APPLICATION NO.	FILING DATE	FIRST NAMED INVENTOR	ATTORNEY DOCKET NO.	CONFIRMATION NO.
09/677,058	09/29/2000	Edward Friery	14097	1687
7590	06/10/2002			
Sally J Brown Autoliv ASP Inc 3350 Airport Road Ogden, UT 84405			EXAMINER	
			LUM, LEE S	
			ART UNIT	PAPER NUMBER
			3611	
DATE MAILED: 06/10/2002

Office Action Summary

DETAILED ACTION

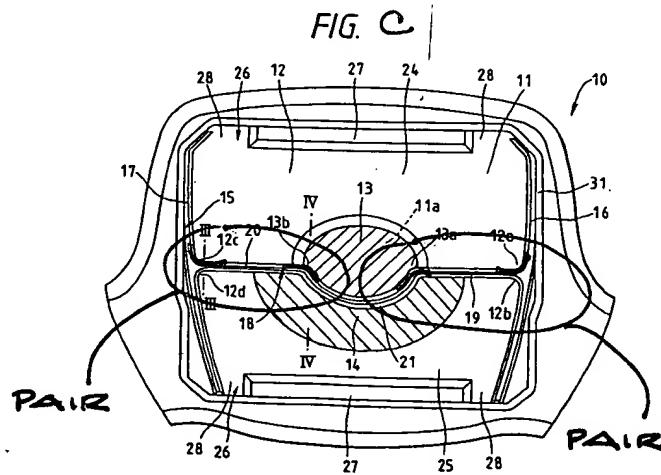
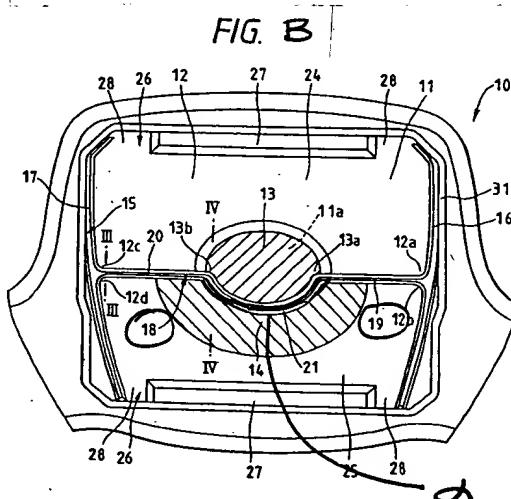
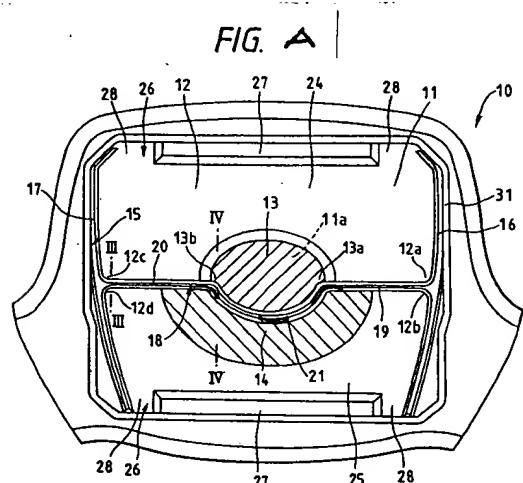
seam 15 ("H-shape" - Col 5, lines 40-41) in the face portion, comprising nonlinear portion 21 having first and second ends (Fig 1), and a plurality of bends, including ones with sharp corners (12a-d), and of nonuniform size and shape, in consecutively alternating directions (the latter outlined in red in Fig A),

the seam further comprising linear segments 18/19 proximate first/second ends of the nonlinear portion, with nonlinear segment α between these segments (the latter outlined in red in Fig B),

Re Claim 8, the patent discloses a plurality of pairs of bends (Fig C).
